SERVICE Counselor

PACKARD MOTOR CAR COMPANY

VOL. 27, NO. 11

NOVEMBER, 1953

Reverse Brake Piston Seal Retainer and Brake Band Adjusting Screw

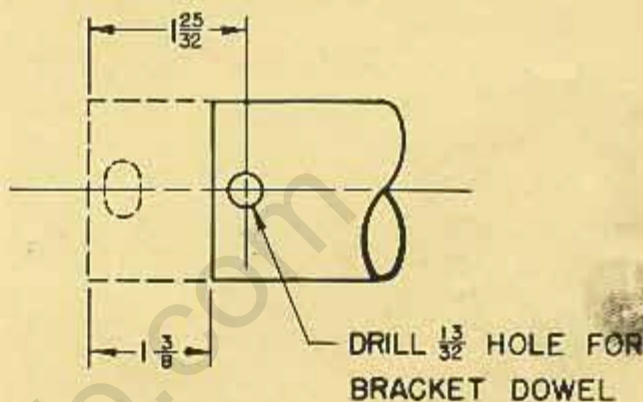
It is possible for the seal to be forced through the retainer if the reverse brake band is adjusted too loose. If the band is adjusted too loose, the reverse piston travels so far that the inner edge of the seal catches in the radius of the piston and then the high reverse oil pressure forces the seal through the retainer. Upon close examination the inner part of the retainer will be found pushed outward.

In a few cases, reverse band adjustment could not be obtained because the adjusting screw would bottom in the transmission case before the band was properly adjusted. This condition gives a correct torque reading but a false band adjustment.

A recent alteration, now effective in production, increased the thickness of the seal retainer from .022" to .0315". The length of the adjusting screw extension (ground section) was increased from $\frac{3}{4}$ " to 1" by decreasing the length of the threaded section by $\frac{1}{4}$ inch.

In the event this condition is encountered, it is advisable to install the new seal retainer and adjusting screw.
